OFFICIAL STAR CLASS MEASUREMENT CERTIFICATE

Report from International Measurement Committee

Star No. 3447

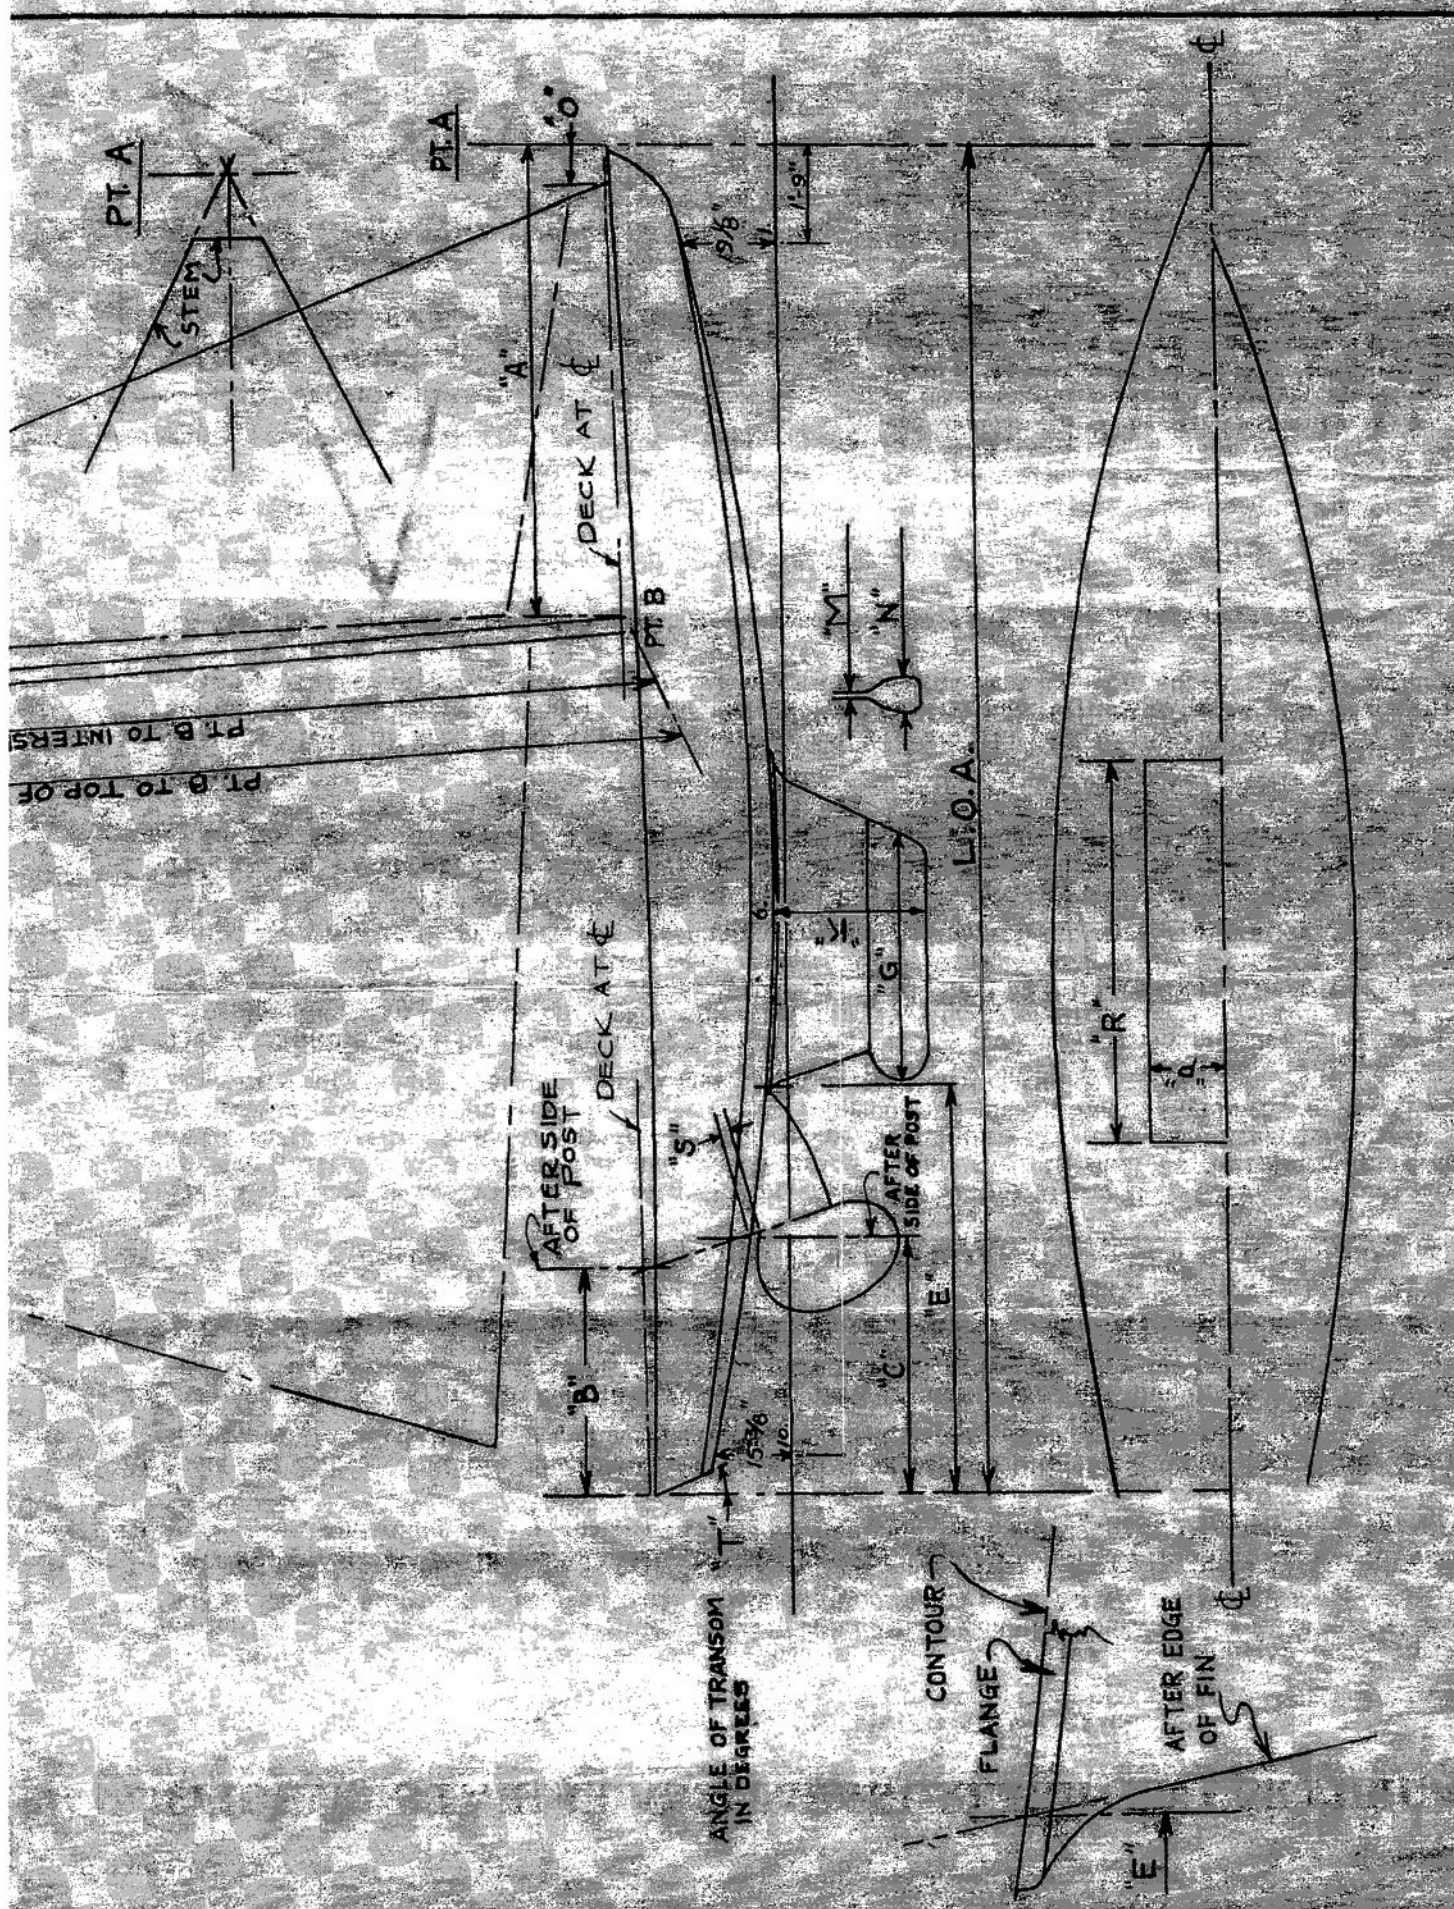
The Measurement Certificate for this boat cannot be approved due to the following points which do not comply with the Specifications:

JIBSTAY FROM "B" - 22' 1" - MIN 22' 3"

CHINE HEIGHT STATION (6) - 9 2/16 -

MAXIMUM - 8 5/16"

- ☐ The points in question must be remeasured by a Certified Measurer and the results submitted to the Measurement Committee.
- ☒ The points in question must be altered to conform to the Specifications and then remeasured by a Certified Measurer and submitted to the Measurement Committee.

In regards the specⁿ 3447 of Mr Vymen
& myself I rechecked the measurements
on the boat and find that I was in error
in regards to the china height of station
6, instead of it being $9\frac{3}{16}$ it is $8\frac{1}{16}$. I had
allowed a correction for the keel fitting
strap when taking the contour measurement
but had neglected to apply it to the
china height at station #6

After reexamining the job story from B
I find that it is 22 ft 8 in and that I
had erred in copying the measurement
down from my work sheet
